Product Change Notice (PCN)

Subject: Change of Standby current specification at high temperature for Renesas 32Mbit/64Mbit SRAM products

Publication Date: 4/25/2024

Example of Marking

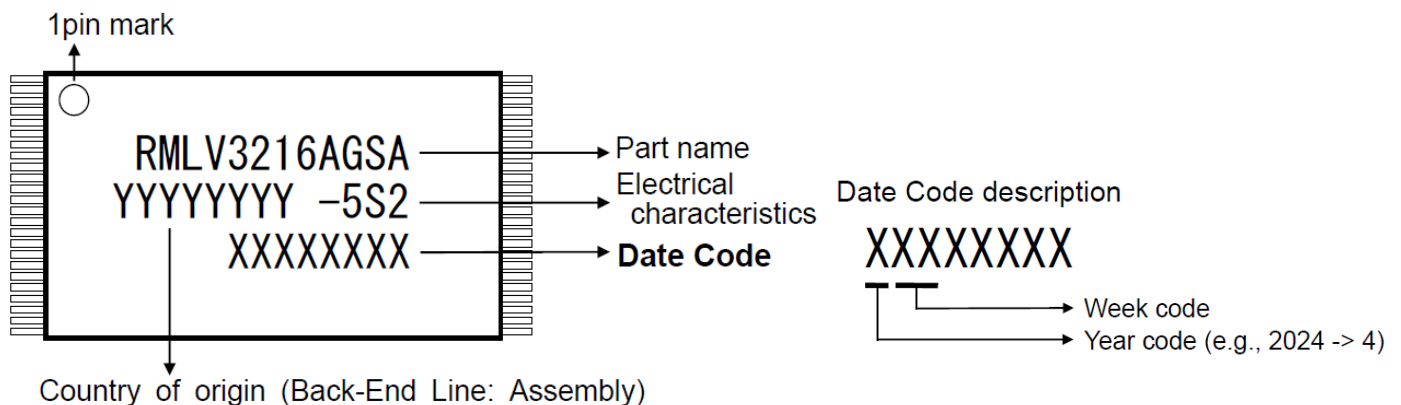
Identifiable by the Date Code marked on the package. Date Code of product after change is starting with 417XXXXX. Please refer below for example of marking and Date Code description.
